NEW FEATURES

■ C59 MANUAL TRANSAXLE

1. General

2. Shift and Select Lever

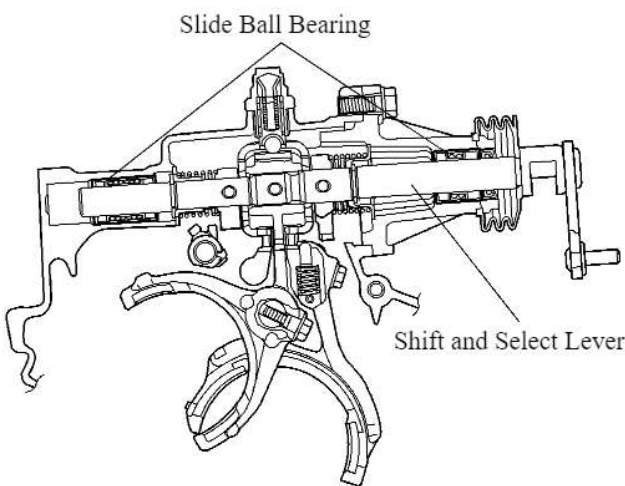
The support for the shift and select lever has been changed from a bushing to a bearing, which reduces the amount of effort required for shifting, thus improving the ease of operation.

3. Synchromesh System

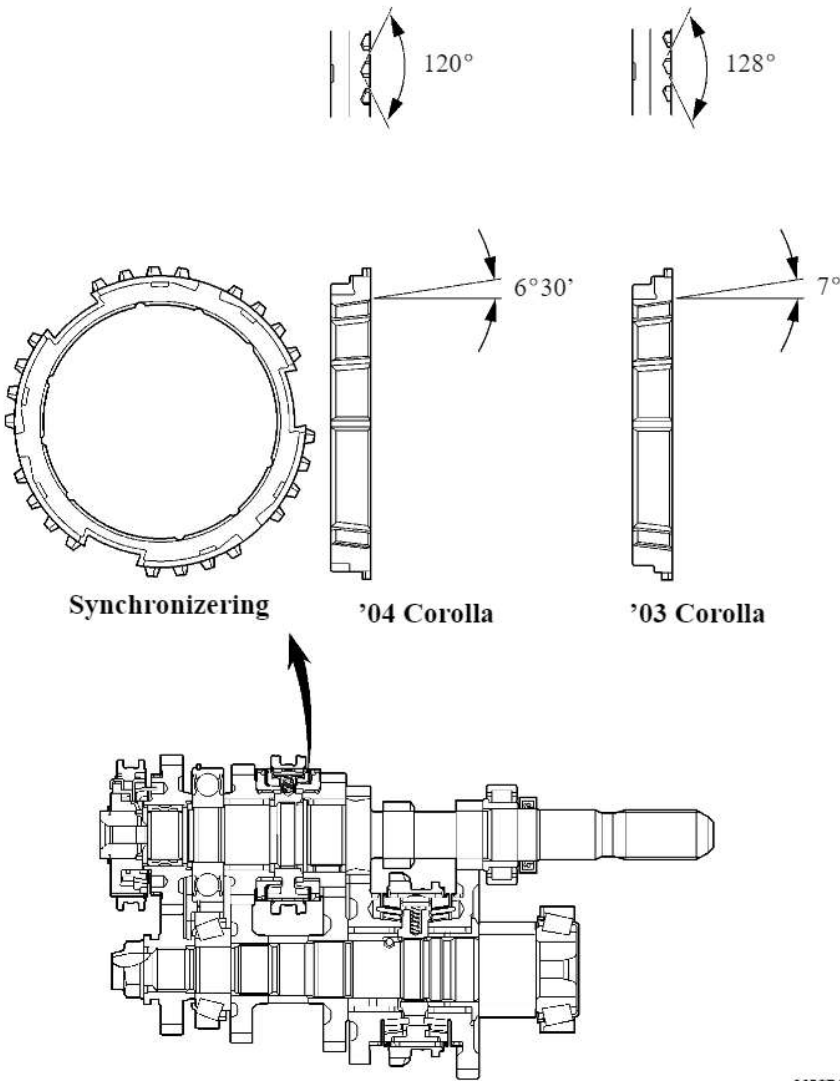
The shape of the splines and the cone of the synchronizing ring for the 3rd and 4th gears has been changed in order to reduce the amount of effort required for shifting, thus improving the ease of operation.
